CASE#: C15-2015-0110 LOCATION: 1631 Palma Plaza

CITY OF AUSTIN * CAT (APPLICATION TO BOARD OF ADJUSTMENT GENERAL VARIANCE/PARKING VARIANCE

HANCOCK RESIDENCE
1631 | PALMA PLAZA | 78703

The residential zoning review has been rejected for the following reasons:

1214
05.07.15
BOA VARIANCE
AREA OF
ELEVATION CHANG
ATIA

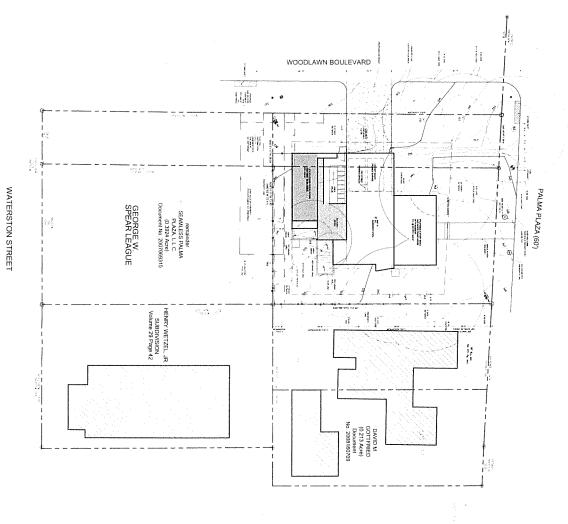
The topography drops significantly just to the west of the building footprint between Tree 150,151 and 153. Subchapter F Article 3.3.3 B-2 states that the finish floor cannot be more than 3' above the average elevation at the intersections of the front yard setback and the side property line. Because of this drop in grade, the average elevation of 544.25' calculated per Subchapter F Article 3.3.3 B-2 is much lower than the actual elevation located near the front entry which is 547.4'. The finished floor elevation at the entry of the first floor is 549.00'

The sudden drop in elevation seems to have been manipulated in order to provide a flat area for the driveway that currently exists on the site. There is a two-tiered retaining wall which provides visual evidence of the manipulated natural grade.(Refer to A1.1d) This existing driveway will be demolished and relocated off of Woodland Blvd adjacent to the new garage. Also, OWANA has requested that the North Facade be preserved which affects the Finish Floor of the main level (Level -1) of the house. Since the preservation of the North Facade dictates the finish floor elevation we are unable to drop the house any lower which prevents the project from fulfilling the requirement stated in Subchapter F Article 3.3.3 B-2.
